**Sandyford Business District
Cycle Infrastructure Review**

Discontinuous Cycle Facilities

P18-055-DG-002

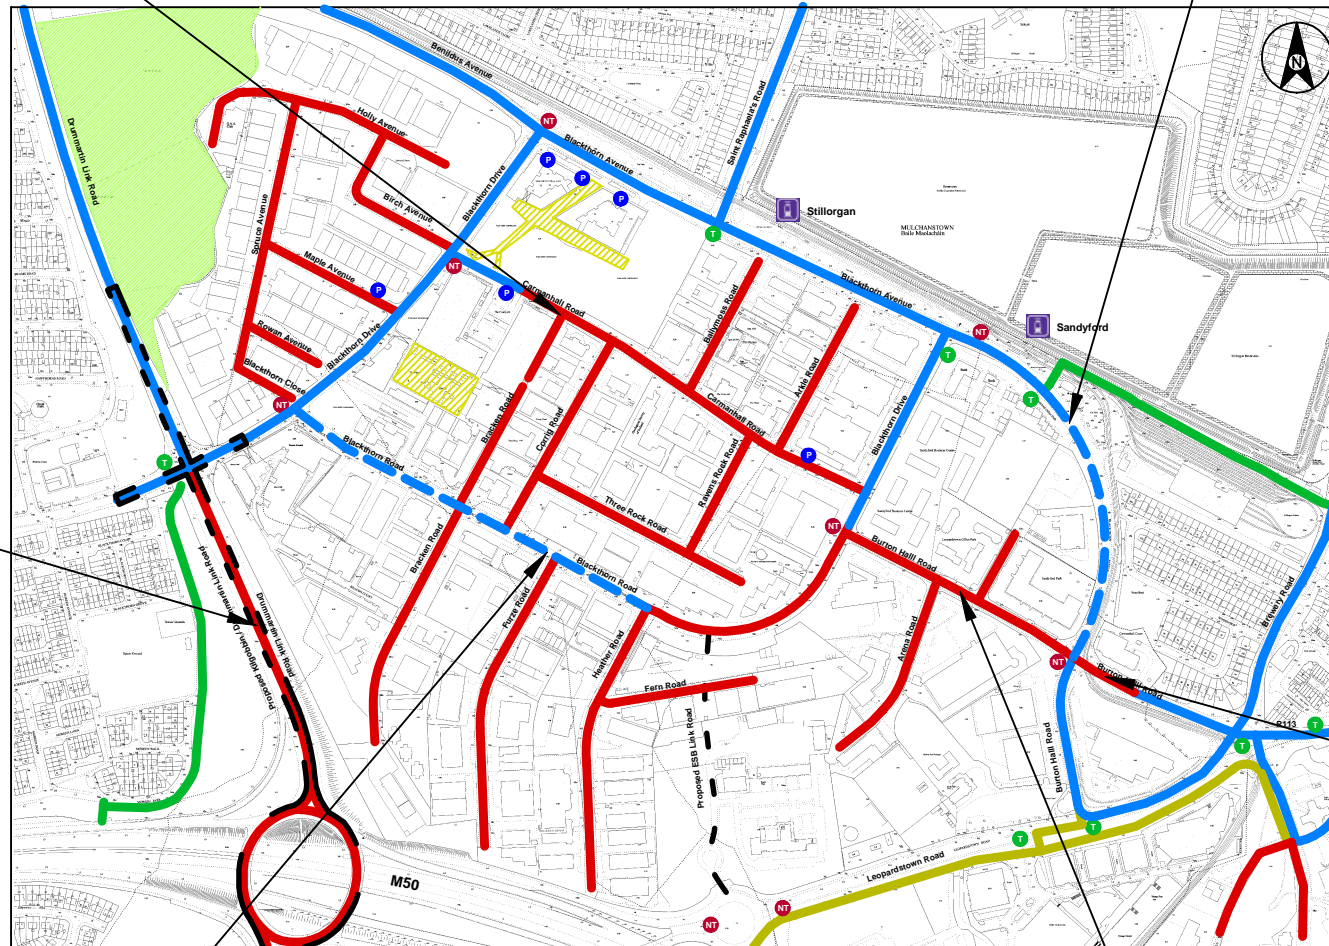
Priority 3 Issue

Insufficient cycle facilities provided on Carmanhall Road which is considered a main spine road within business district.

Priority 2 Issue

No cycle facilities provided for northbound cyclists from Burton Hall Road to Blackthorn Avenue which may lead to cyclists continuing on footpath.

Priority 1 Issue

No cycle facilities provided on Drummartin link road from its junction with Blackthorn Drive continuing south over the M50.

Priority 1 Issue

Short section of road with no cycle facilities provided between existing cycle facilities. Facility changes in quick succession from cycle track to shared use surface and no cycle facilities for cyclist on Blackthorn Avenue travelling east on Burton Hall Road.

Priority 2 Issue

No cycle facilities provided on Blackthorn Road which is considered a main spine road within business district. Several cyclists identified cycling on grass verge on southern side of road where there is a risk of slips and falls.

Priority 1 Issue

No cycle facilities provided on Burton Hall Road between it junctions with Blackthorn Avenue and Blackthorn Road. Several cyclists identified cycling on grass verge on southern side of road.

Provide cycle facilities on both side of Carmanhall Road to tie into existing cycle facilities.

Provide a contraflow cycle track on the western verge of Blackthorn Avenue.

Provide cycle facilities on Drummartin Link Road from existing facilities on Kilgobbin Road to the south and north of the Blackthorn Drive signalised junction.

Relocate Bus bay and provide continuous cycle facilities on Burton Hall road.

Provide cycle facilities on both side of Blackthorn Road to tie into existing cycle facilities.

Provide cycle facilities on both side of Burton Hall Road to tie into existing cycle facilities.
